SERVICE PROGRAM BULLETIN

APPLICABILITY: 2026 MY Outback (Turbo)

NUMBER: WRE-26

SUBJECT: Rear Exhaust Pipe/Muffler Gasket

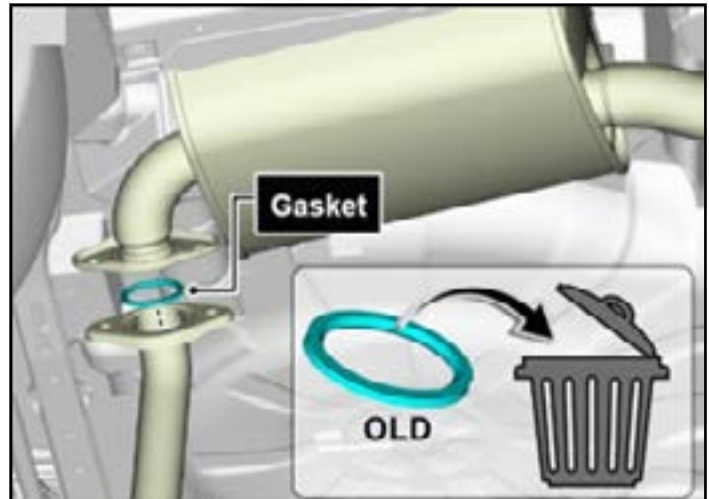
STEP 2: Loosen the nuts securing the rear exhaust pipe and muffler, remove the bolts, and discard the nuts as they are not reusable.

STEP 3: Remove the gasket and discard it as non-reusable.

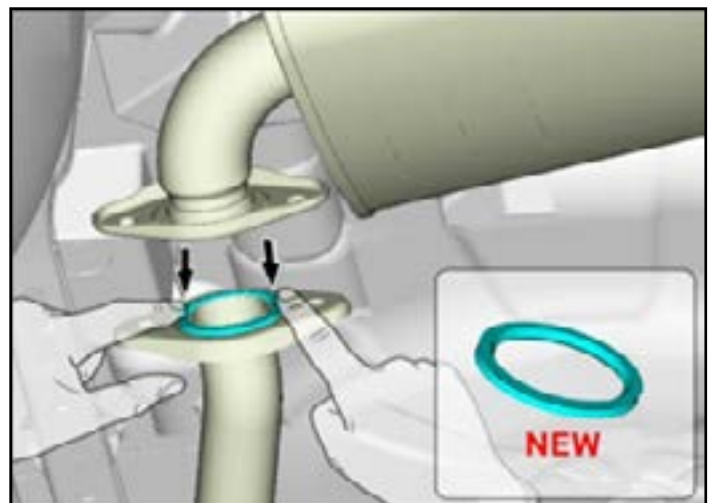
NOTE: It is not necessary to remove the rear exhaust pipe, or the mufflers from the vehicle to replace the gaskets.

STEP 4: Evenly press on the NEW gasket and install it onto the rear exhaust pipe.

STEP 5: Connect the rear exhaust pipe and the mufflers, then secure them hand tight with the bolts and NEW nuts.

STEP 6: Tighten the nuts to **48 Nm (35.4 ft-lb)**.
